SINGAPOREAN NOTICES TO MARINERS

The monthly Notices to Mariners contain information required to keep charts and publications published by the Hydrographic Division, Maritime and Port Authority of Singapore up-to-date.

NOTICE NO.	DESCRIPTION	PAGE NO.
-	New Charts and Publications	2 - 5
*108	Singaporean Chart GSP1/SP1	6
109	Singaporean Chart 200	6
*110	Singaporean Chart 502	6
*111P,112T, *113T	Temporary and Preliminary Notices	7
*114	Singapore Port Marine Notices/Circulars	9
*115,*116	Amendments to Publications	10 - 11
-	Reprint of Maritime Safety Information	12 - 14
-	Extract of Admiralty Notices to Mariners for Dual-Badged Charts	15 - 19

2. Page 134

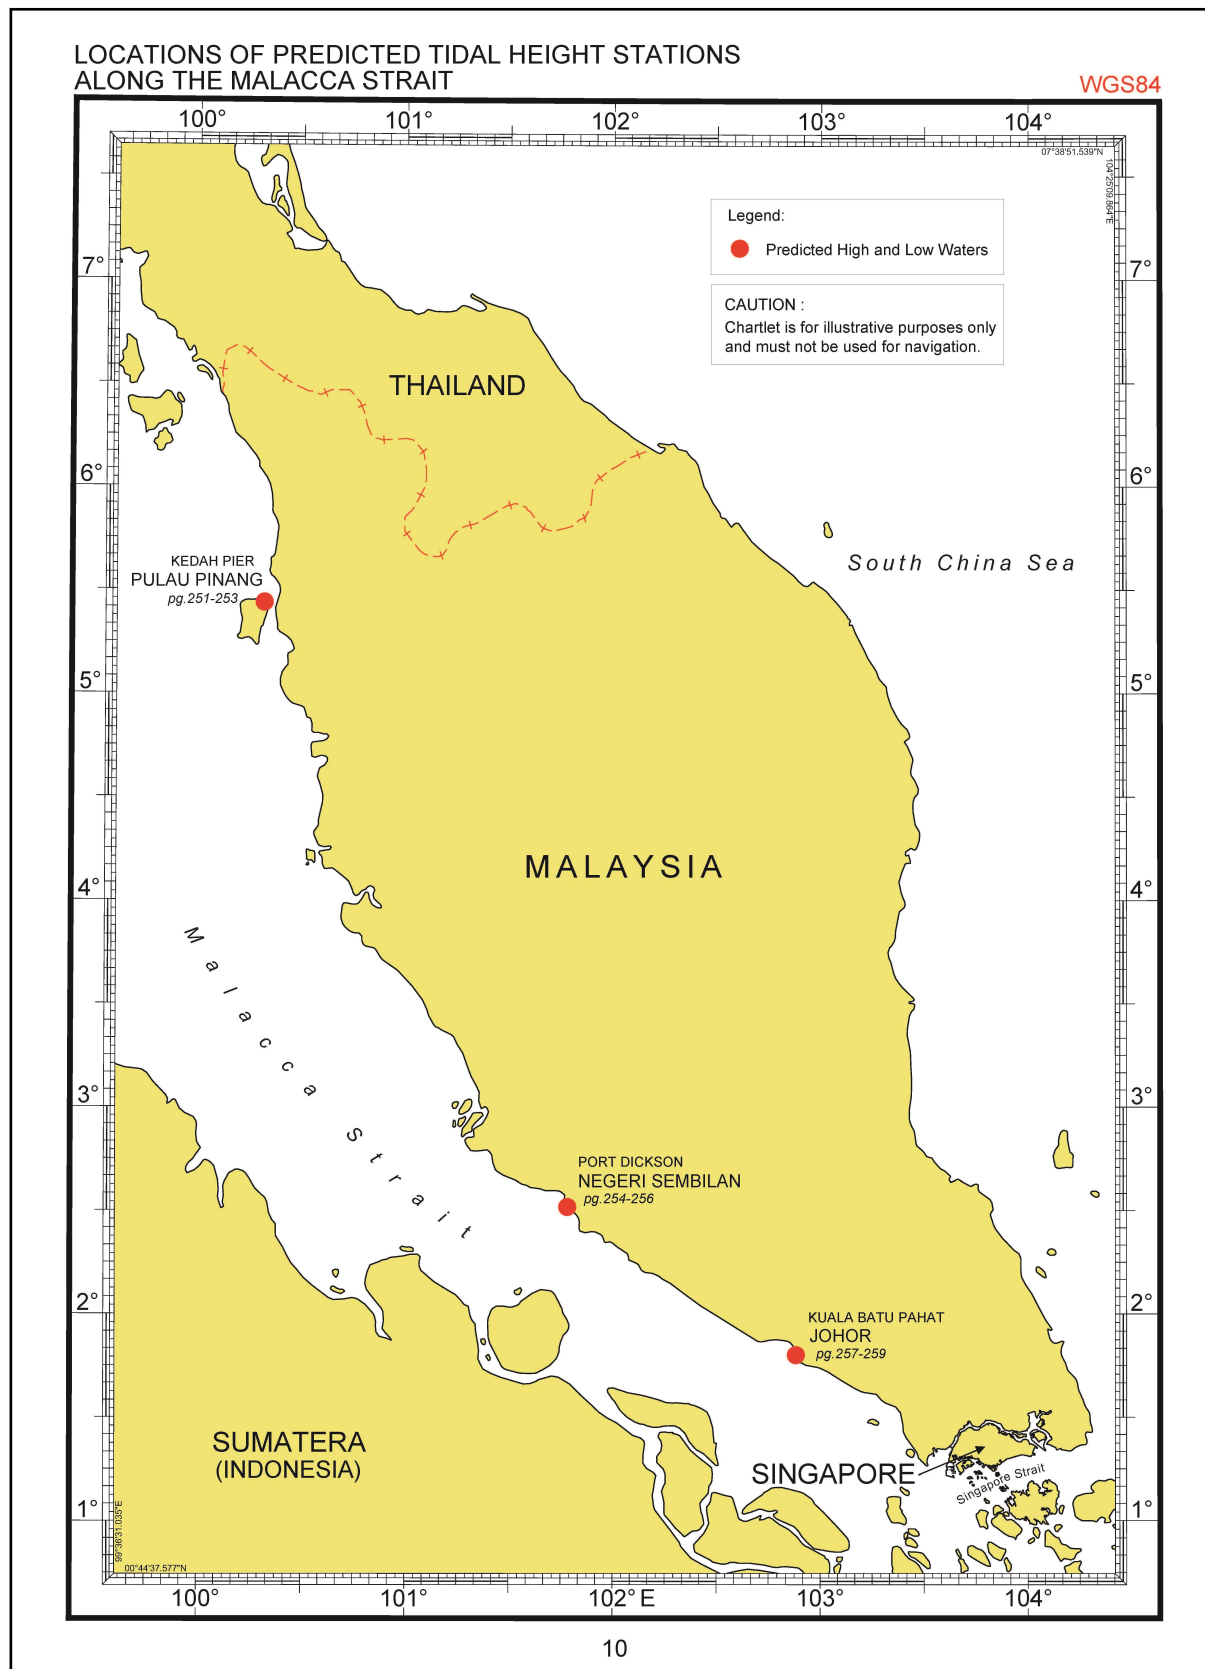
TEMASEK FAIRWAY

Insert the following:

Name Of Beacon / Buoy	Position Lat. N Long. E Deg Min	Structure, Colour & Shape	Light Characteristic	Owner
TMS 3	01°16.198' 103°38.707'	Red can	Fl.R.5s	MPA

Delete the following:

Name Of Beacon / Buoy	Position Lat. N Long. E Deg Min	Structure, Colour & Shape	Light Characteristic	Owner
F1JV-02 Buoy	01°15.910' 103°38.709'	Red can with radar reflector	Fl(3)R.10s	F1-JV
F1JV-03 Buoy	01°16.297' 103°38.709'	Red can with radar reflector	Fl.R.5s	F1-JV

CORRECTION NO.	SNM EDN NO.	LAST CORRNO NO.	CHART NO.	Location on Chart		
109	12/2021	94	200			X

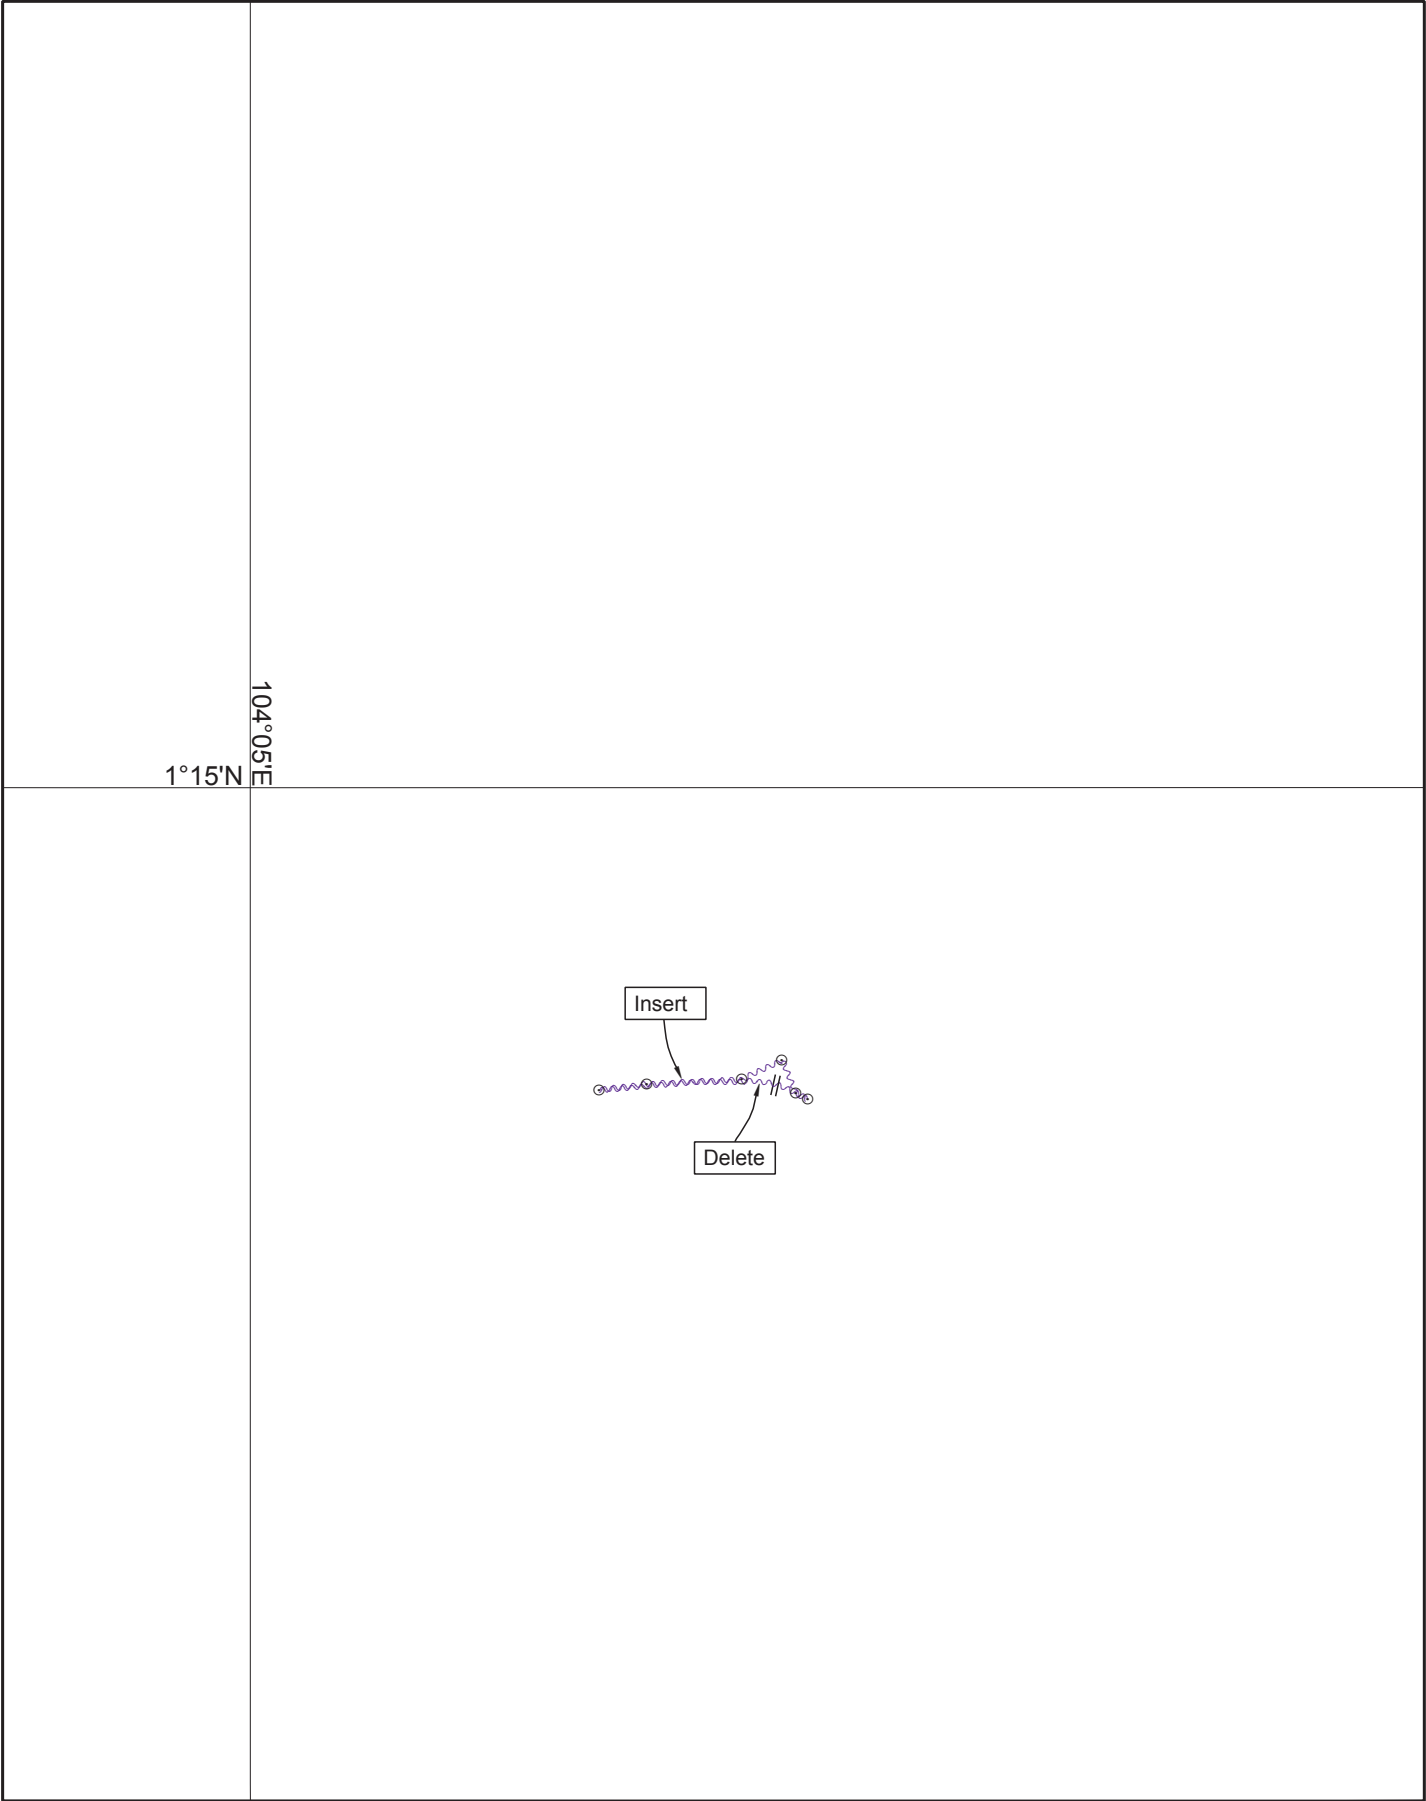
200 4 Ed 01/09/15 Last NM 94/2021 (Royal Malaysian Navy No. 10/193/2021) **NM 109/2021**

Amend light to, *Fl(4)5s* 2°31'33"N 101°46'99"E

Amend light to, *Fl(2)8s18m18M* 2°30'80"N 101°47'30"E
